Re: Consistency Review for Sunrise Wind

We strongly disagree with the Staff Recommendation for Concurrence regarding federal consistency review of the Sunrise Wind project. Such a concurrence would violate the enforceable policy of the Ocean SAMP and lead to irreversible long term exclusion and harm for Rhode Island’s commercial fishing industry.

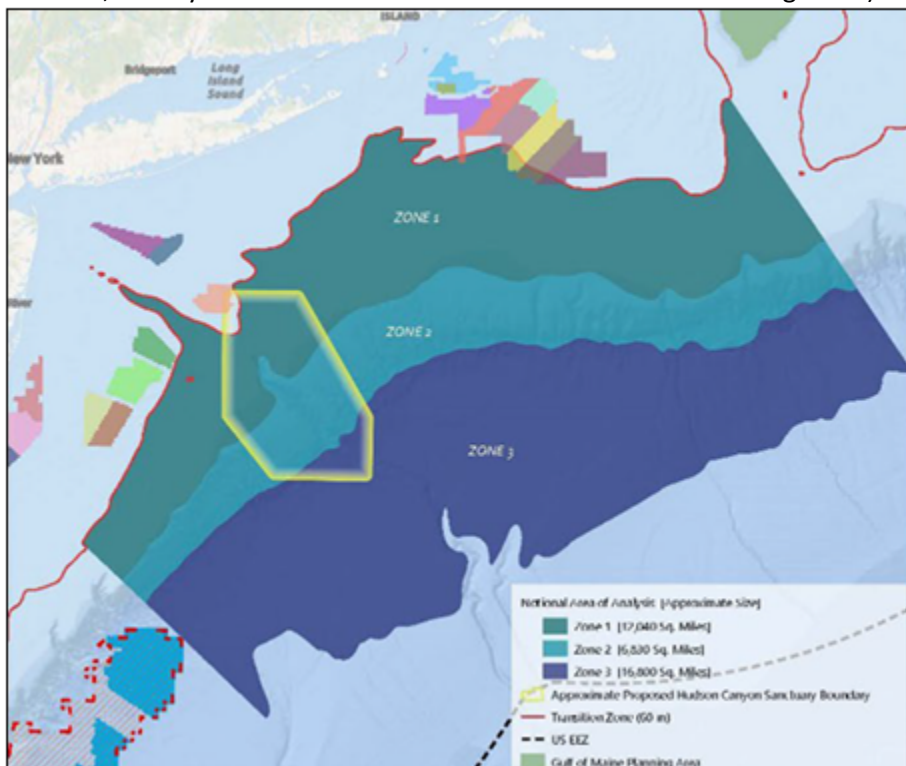
Rhode Island’s own Department of Environmental Management has conducted a report that found that “Very few fishermen do operate mobile gear within the six assessed UK windfarms, and only in cable-free corridors between turbines.”⁶ We refer the Council to Figure 3 of the CRMC staff report, reproduced below. There are no cable free corridors within the Sunrise Wind project.
